ARACHNID INC.

TITLE: 6000 SERIES POWER SUPPLY

DRAWING NUMBER: 38-0019

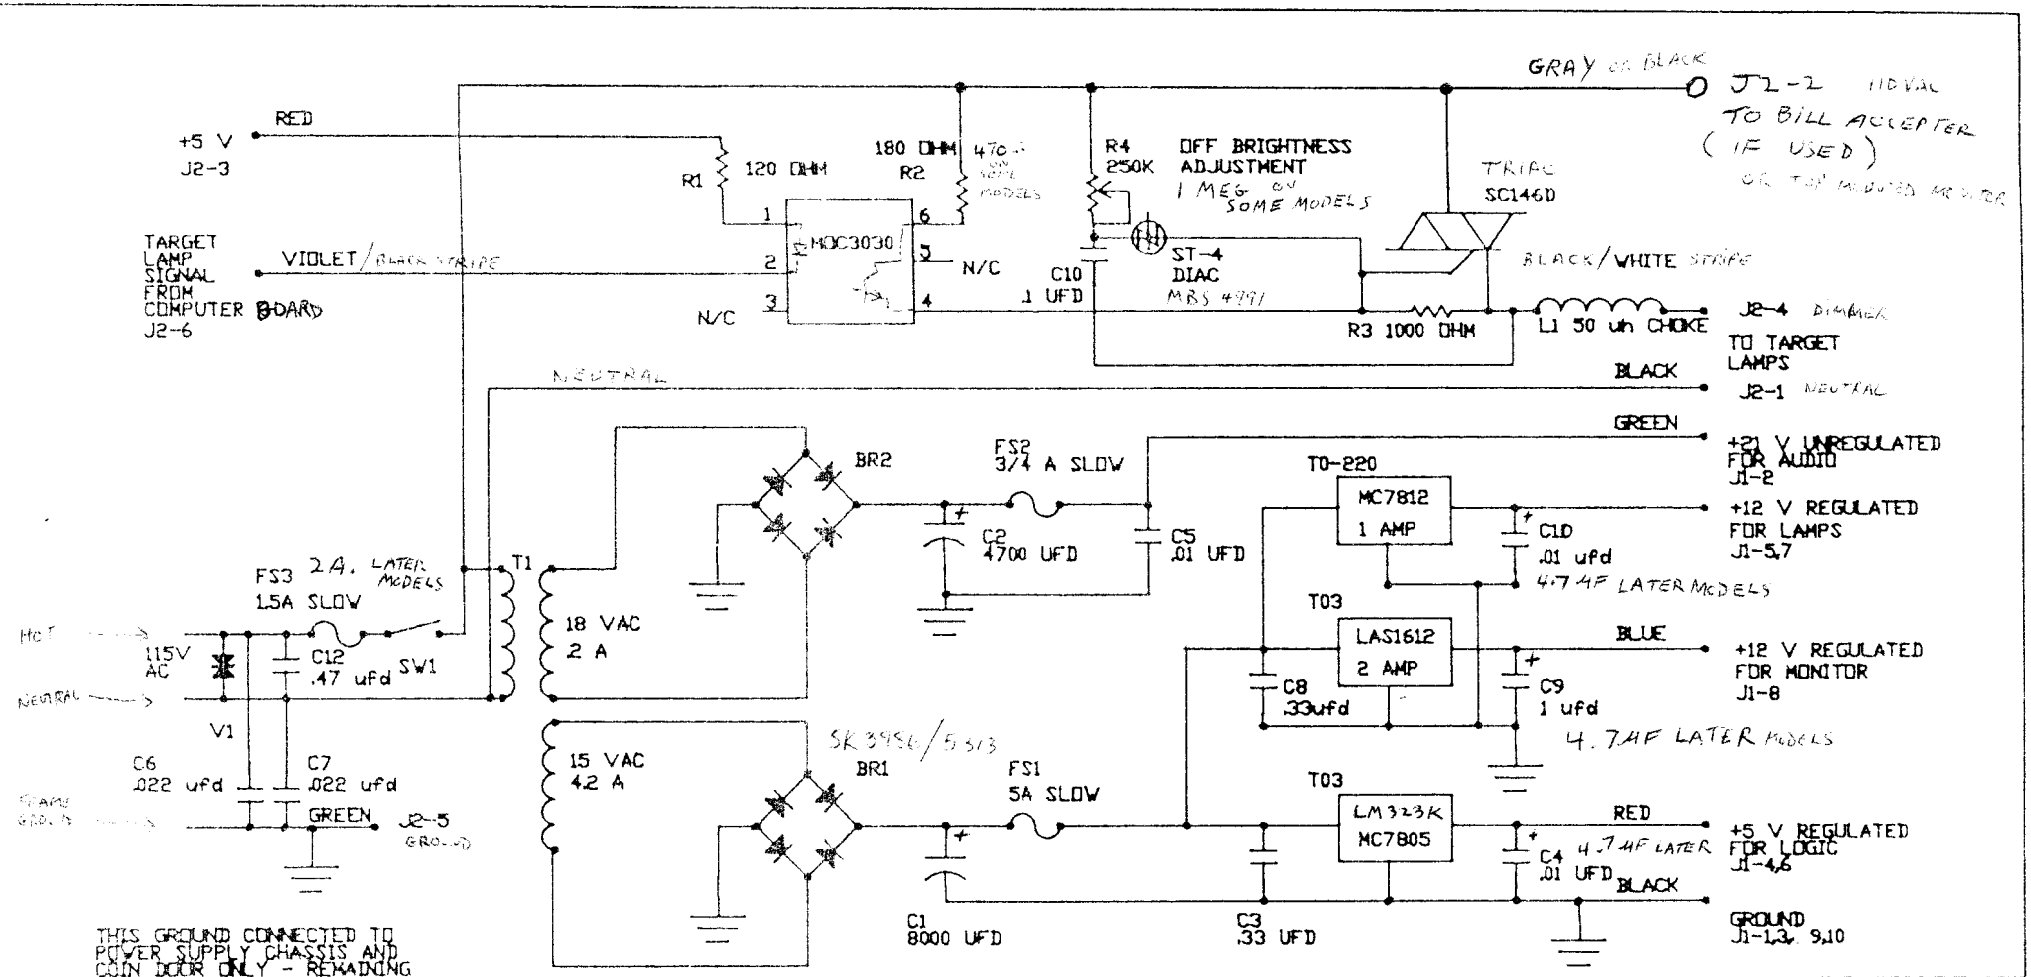
CAPACITOR C-9 IS PRONE TO FAIL, CAUSES LOW POWER TO MONITOR. REPLACE WITH 4.7 MFD @ 35 V TANTALUM
